CONTRACT DOCUMENTS

SITE PLAN

SITE PLAN REVIEW

✓ Name of Proposed Development Continental Cove

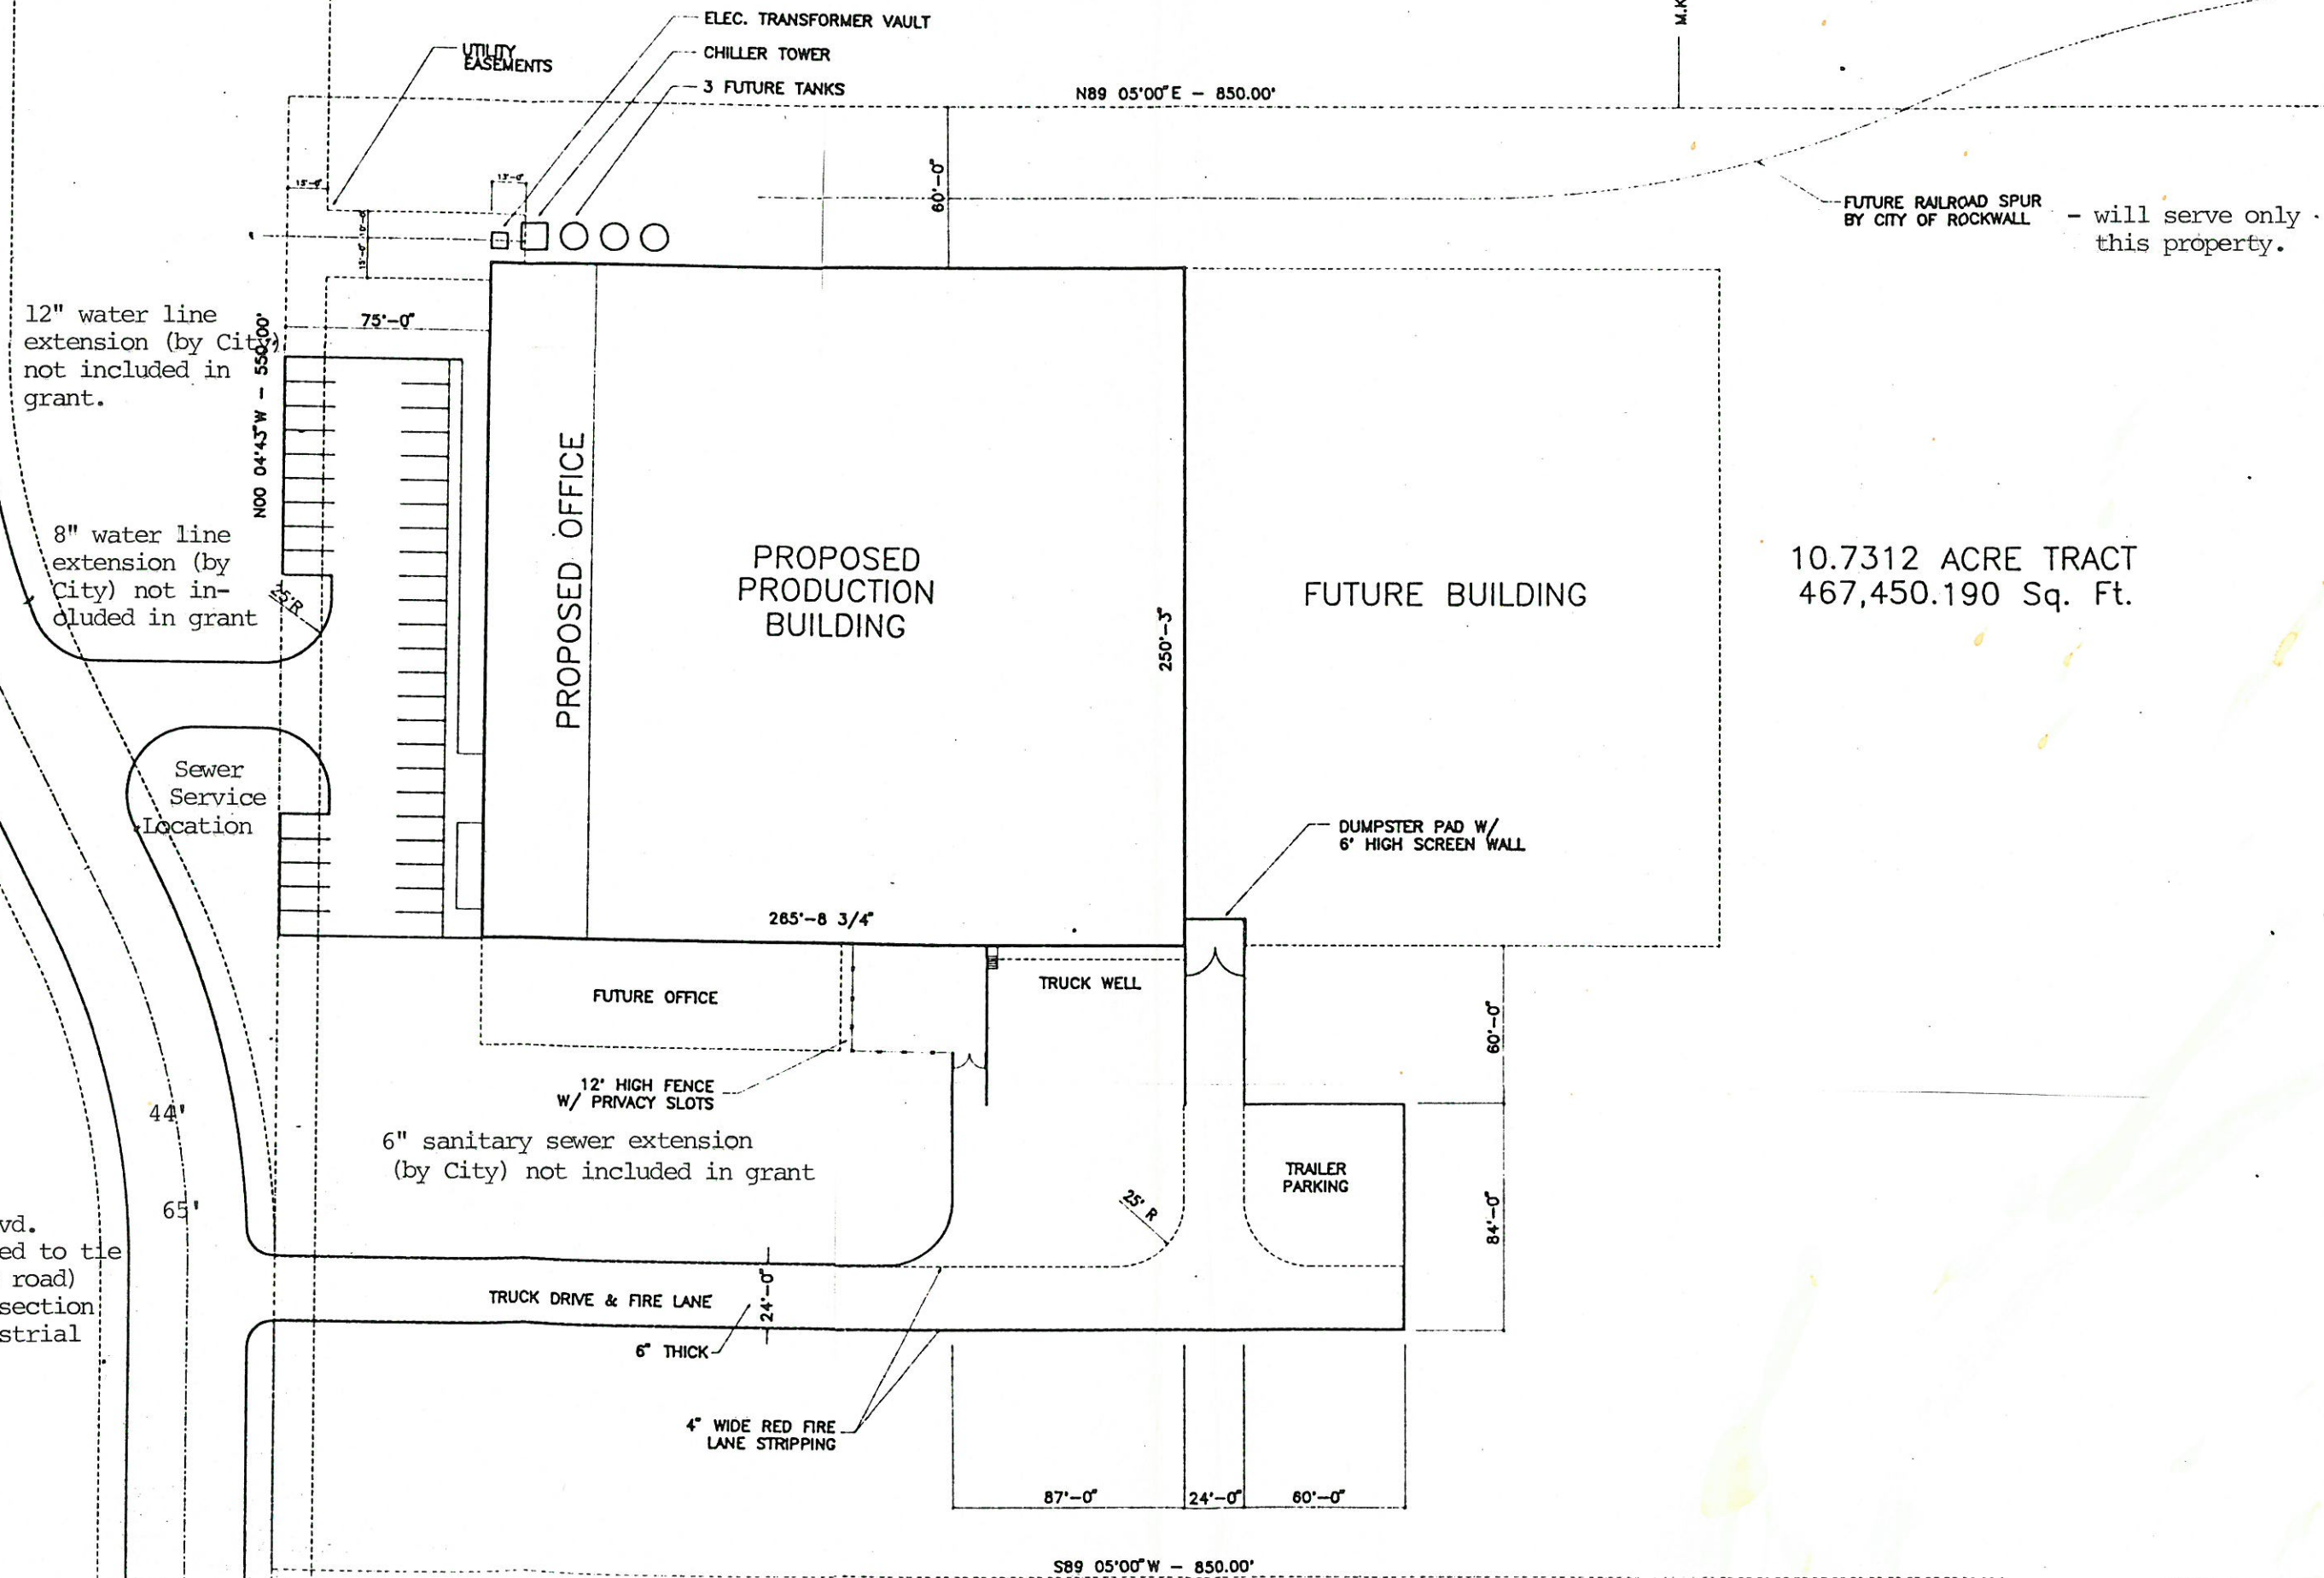
1. add turn arrows on parking lot
2. add 1 tree and move both away from drive
3. reflect change in location of wall off container

these changes will be made - talked to Tom on 10/16/89
